Design Review Report

8-Channel Precision Battery Cell Voltage Acquisition Front-End

Report ID	SNR-R-2607, Rev. 2	Reviewed by	B. Kuznetsov, HighSNR Lab
Date	2026-07-24	Engagement	Expert Audit, SOW SNR-Q-2607
Object	battery_tester_ rev_d.kicad_sch, rev. D of 2026-07-23	Client brief	Symptoms S1–S7, questions Q1–Q5
File MD5	369076eafce2a899c5193ae73f1f1691	Status	Corrected demonstration report

8.1 Conservative dc limits after two-point calibration

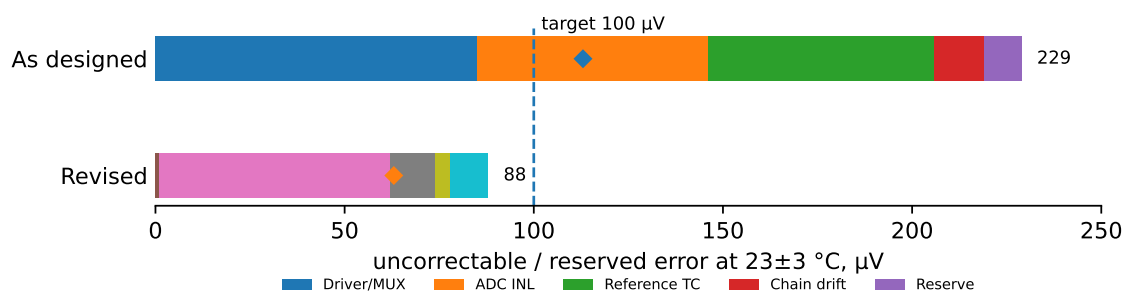
The table below uses arithmetic addition for hard specification comparison. The as-designed column uses the observed upper bow for C-1 because a guaranteed maximum for the combined $I_B R_{FLAT}$ mechanism is not available from the submitted data. The revised column uses maximum or reserved limits. Sample rate is fixed to the calibration rate; cross-rate transfer is reported separately.

Term (μV)	As designed		Revised	
	$23 \pm 3^\circ\text{C}$	$15\text{--}35^\circ\text{C}$	$23 \pm 3^\circ\text{C}$	$15\text{--}35^\circ\text{C}$
Driver/MUX residual nonlinearity	85	85	1	1
ADC INL, maximum	61	61	61	61
Reference tempco (A / D grade)	60	240	12	48
Driver and chain drift	13	54	4	15
Metrology, thermal-EMF, and unmodelled reserve	10	20	10	20
Conservative sum, fixed rate	229	460	88	145
Target	100	250	100	250
Margin	−129	−210	+12	+105
